SLOVENSKI STANDARD
SIST ETS 300 290 E1:2004/A1:2004
01-oktober-2004

Business TeleCommunications (BTC); 64 kbit/s digital unrestricted leased line with octet integrity (D64U); Terminal equipment interface

AMENDMENT

**This amendment A1 modifies
the European Telecommunication Standard ETS 300 290 (1994)**

Figure 1

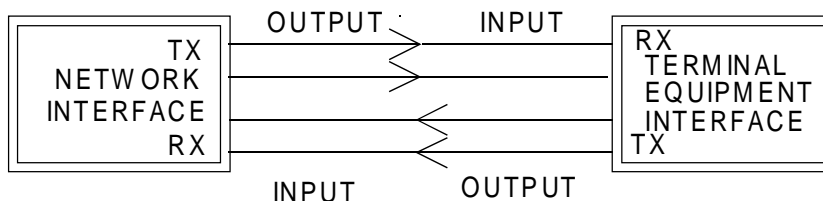
Replace subclause 5.1 with subclauses 5.1, 5.1.1 and 5.1.2 as given below:

The transmit pair is the output from the terminal equipment interface. The receive pair is the input to the terminal equipment interface, as shown in figure 1. Where the terms "output" and "input" are used without qualification in this ETS, they refer to the terminal equipment interface.

Currently no standardized connector is readily available. Consequently, the only method of connection that can be specified in this ETS is the use of solid conductors of 0,4 to 0,6 mm. This ETS requires the TE to be capable of presenting either a point for the attachment of unterminated solid conductors, or solid conductors themselves (see subclause 5.1.1). It is a requirement that such a connection method be available to be provided for use with the TE if necessary.

In order to allow connection to be made using other methods (e.g. connectors), the TE is permitted to be supplied with a connection method suitable for use with those methods (see subclause 5.1.2).
